# ADDENDUM NO. 05 – PORTAGE PUBLIC SCHOOLS – CENTRAL ELEMENTARY SCHOOL BP 4: CONSTRUCTION

# ADDENDUM NO. 5 (BP4)

PROJECT: Central Elementary School Bid Package 4: Construction

ARCHITECT'S PROJECT NO.: 21-237.10

8 S 501

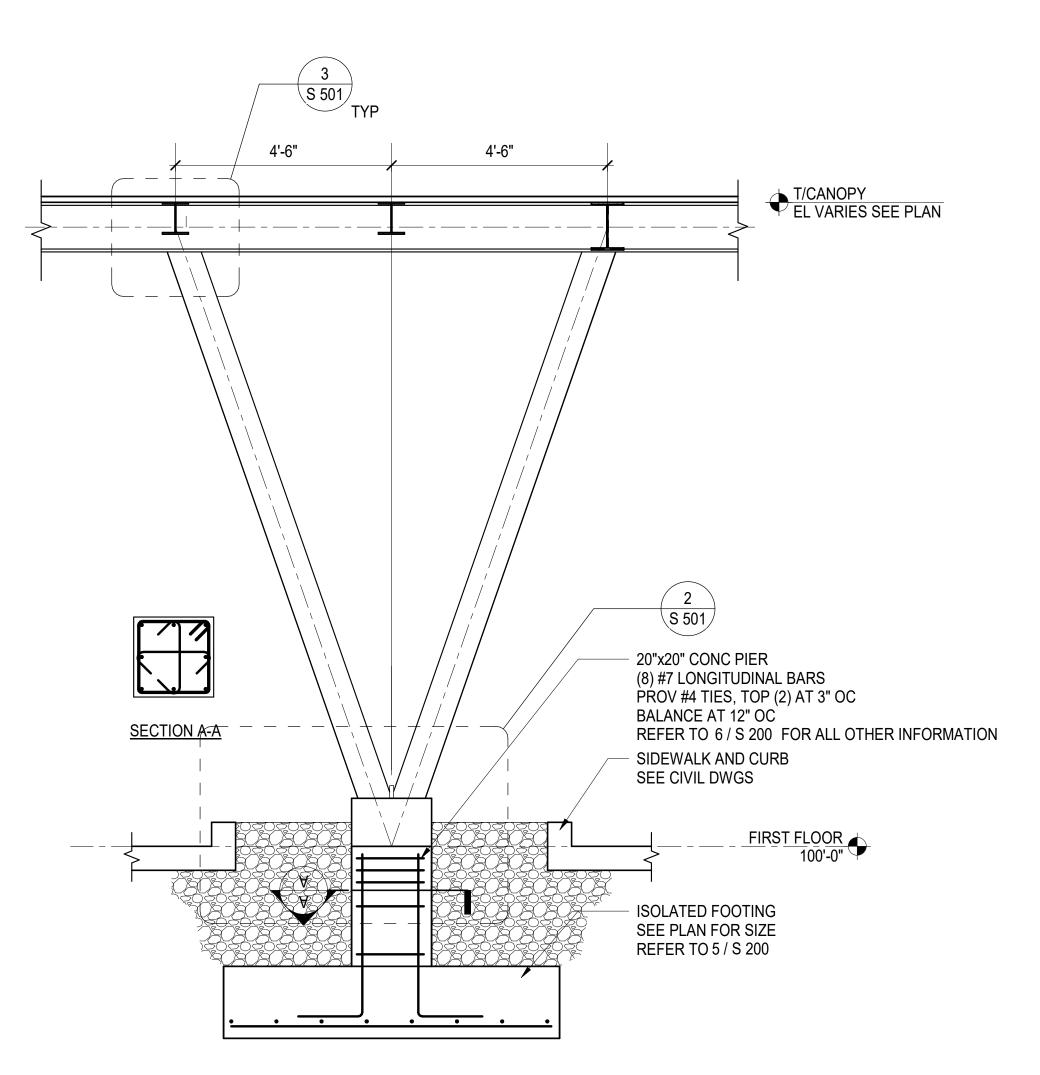
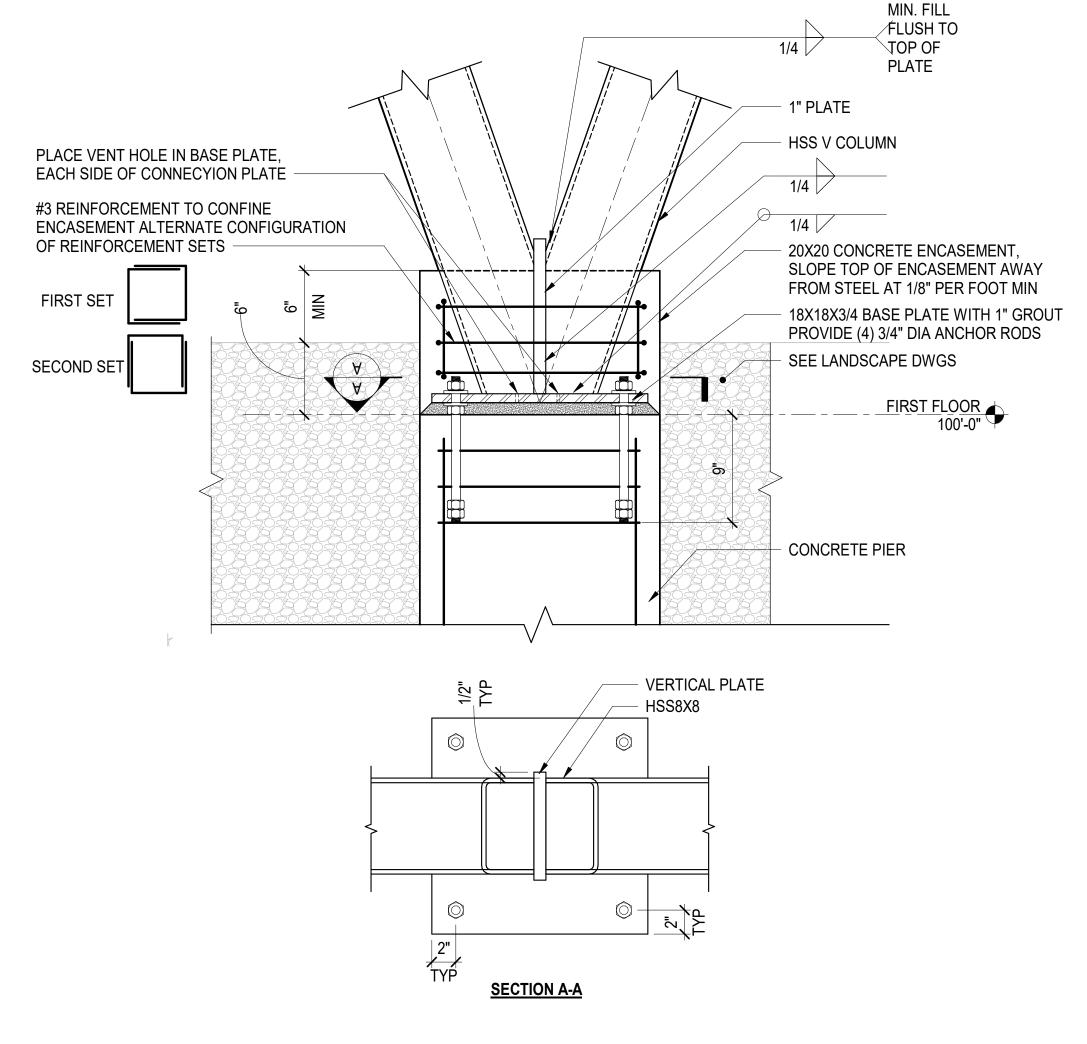
#### ADD-5 Item No. D-1 - Bottom Bearing Plate Connection

Revision to connection from top plate bolted connection to bottom plate seat connection. Refer to detail 8/S501.

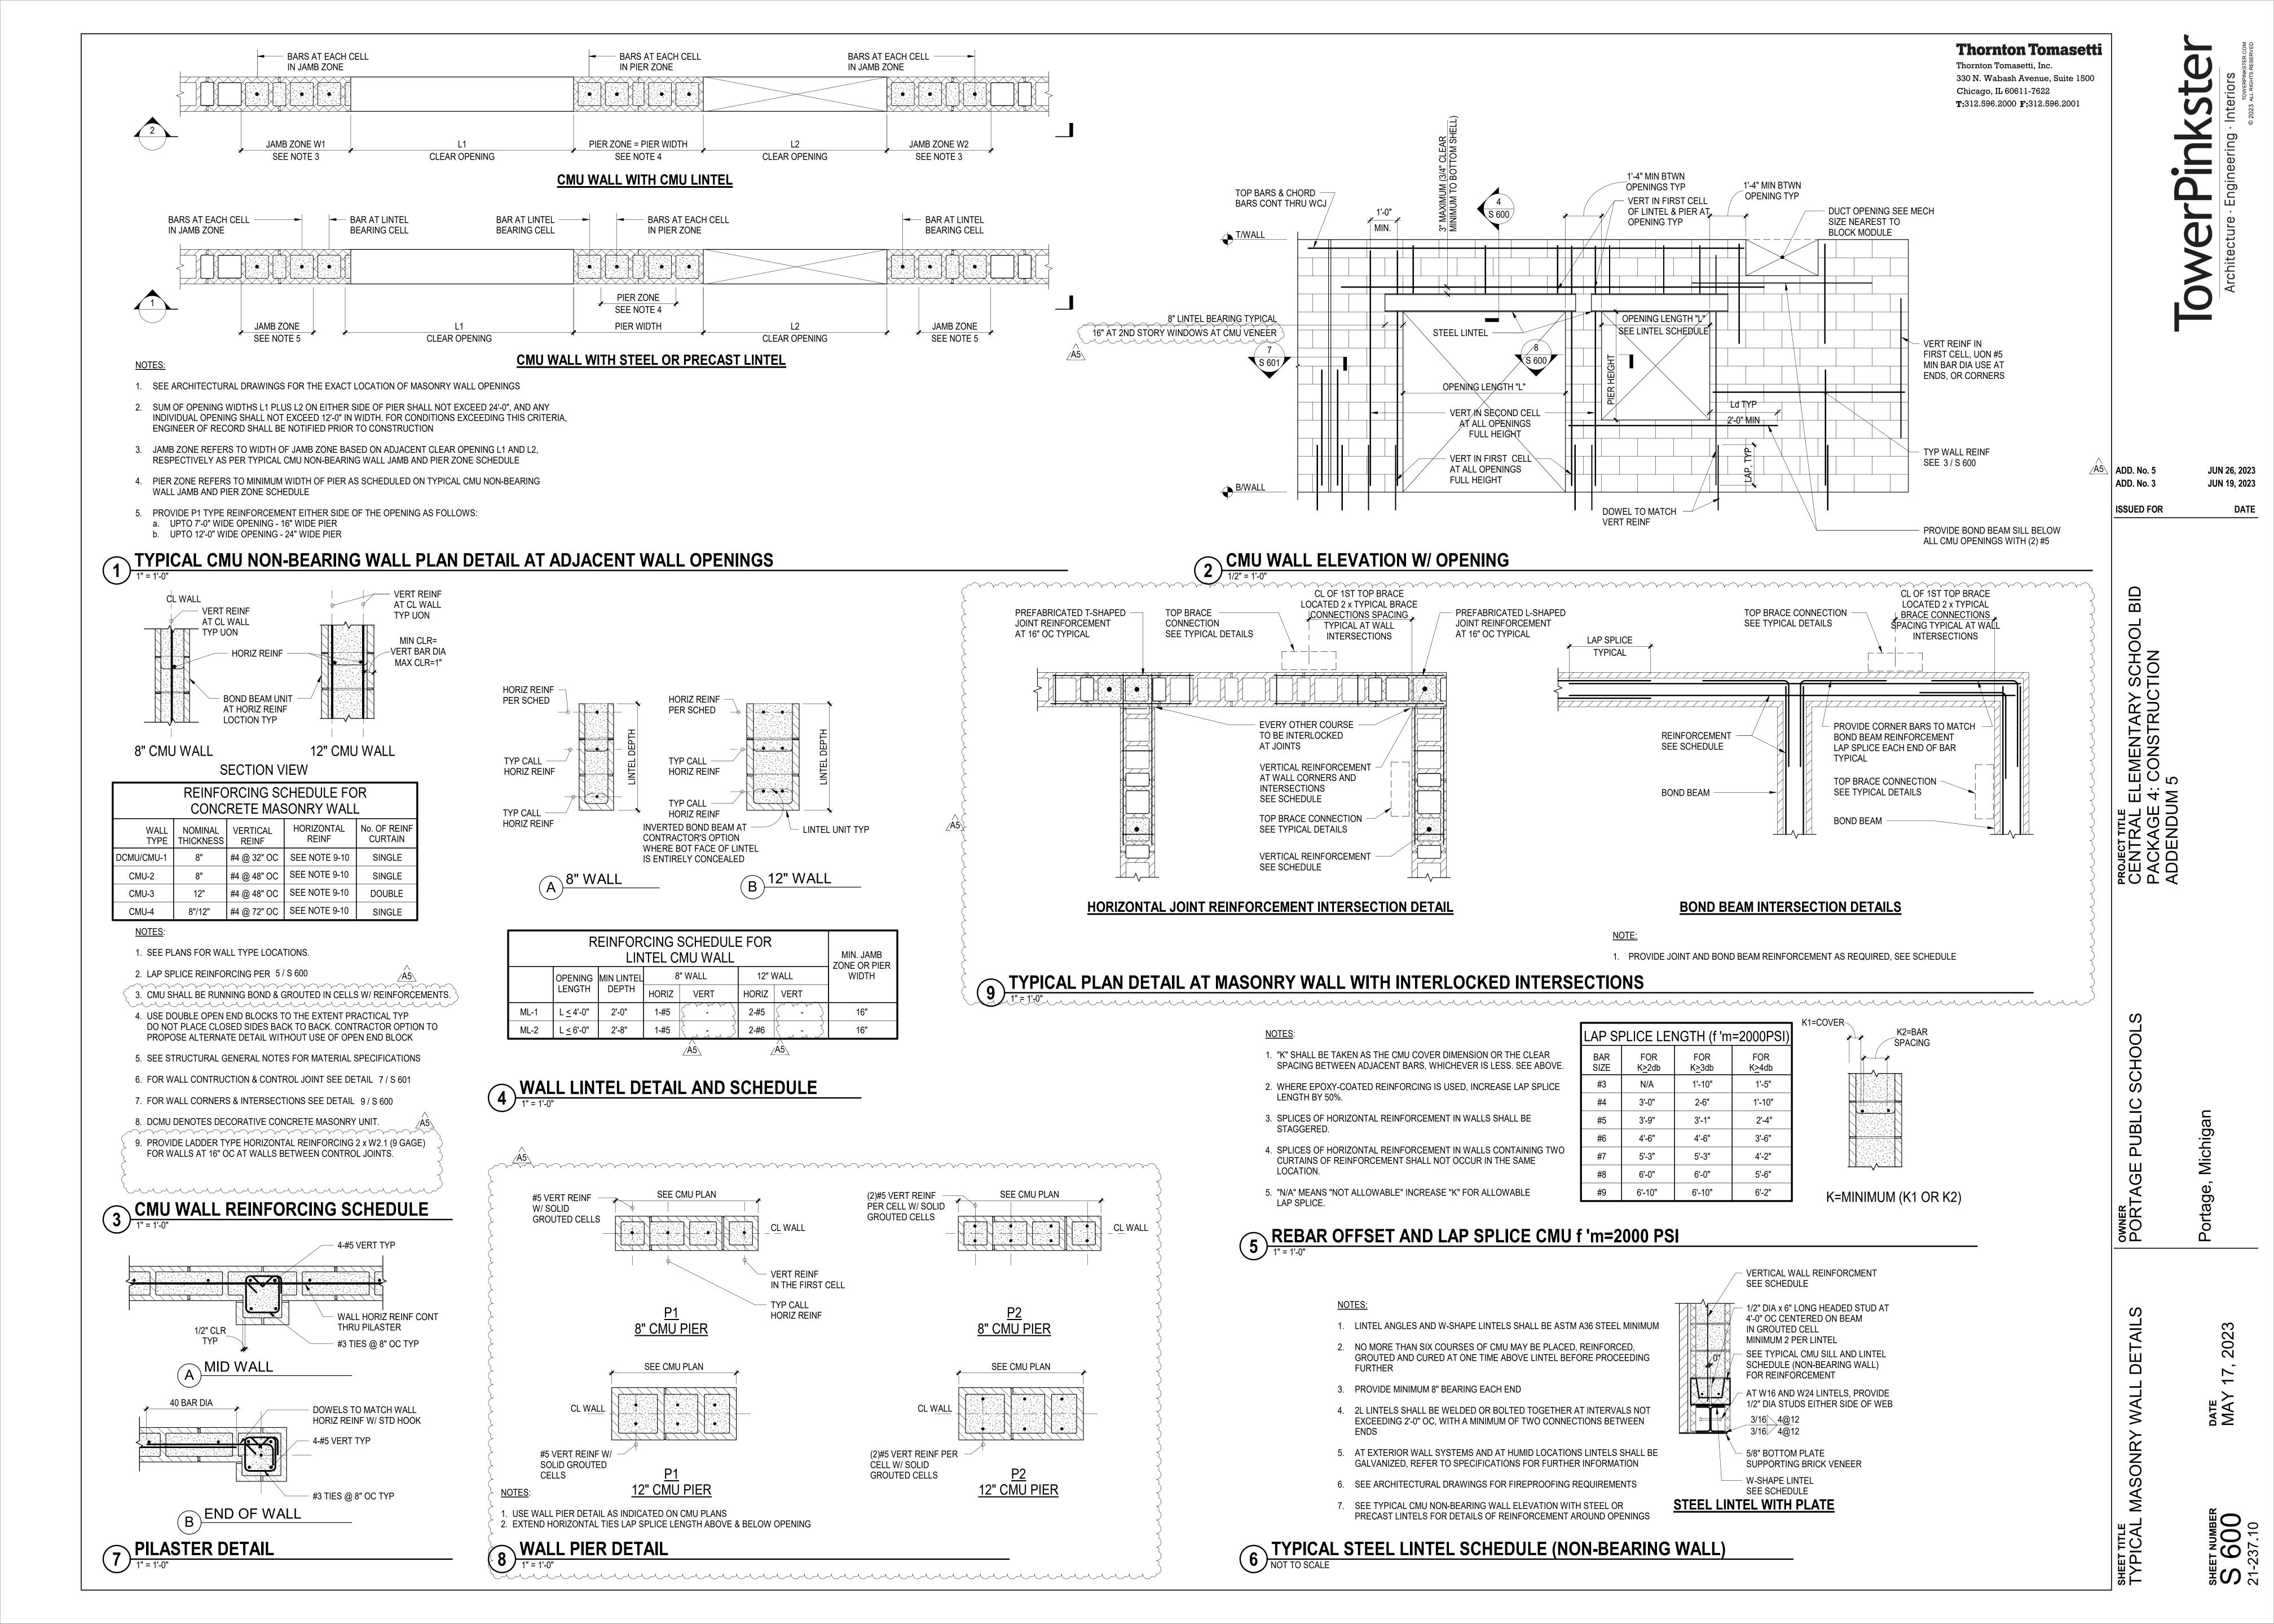
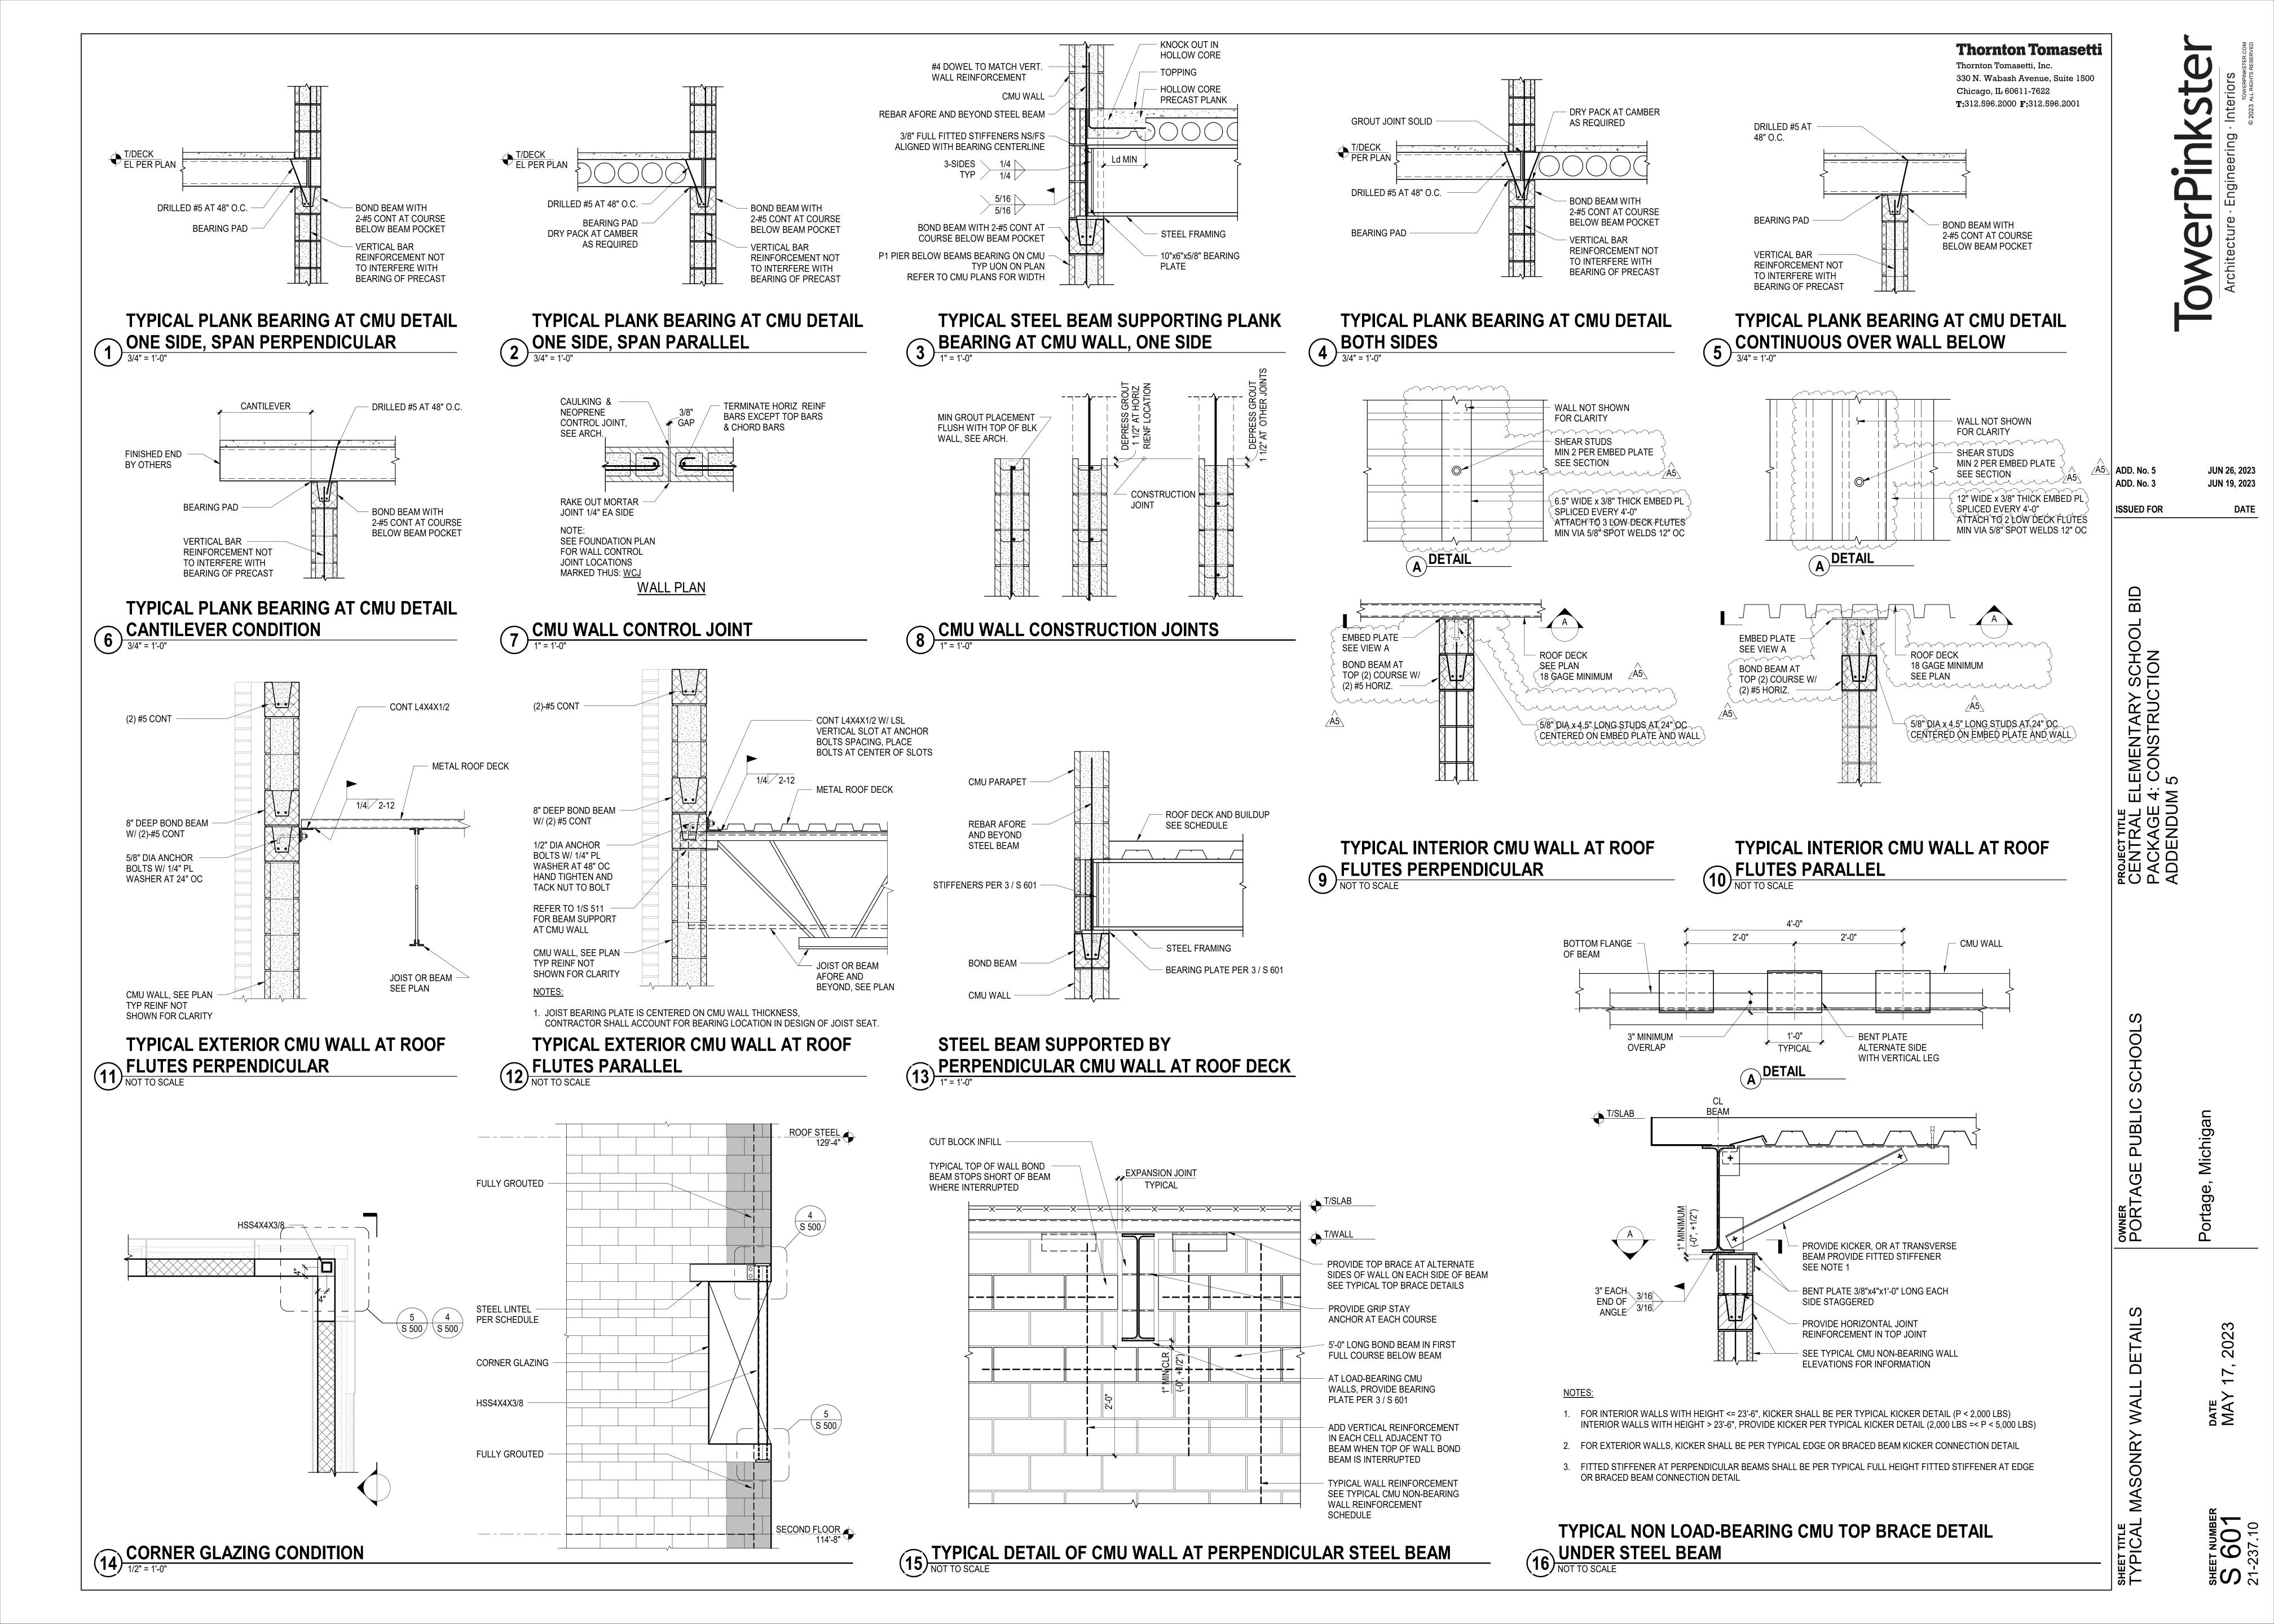
#### ADD-5 Item No. D-7 - Thermal Brackets at Veneer Bearing

Fero Fast thermal bracket detail updated. Thickness of continuous shelf angle is revised.

Revised wall sections to remove shelf angle and bracket in alignment with 2<sup>nd</sup> floor openings. Revised shelf angle and bracket note, added typical note to 1/A321, provide membrane flashing, cavity drainage mesh, weeps and vents at shelf angle [12'-0"h locations].
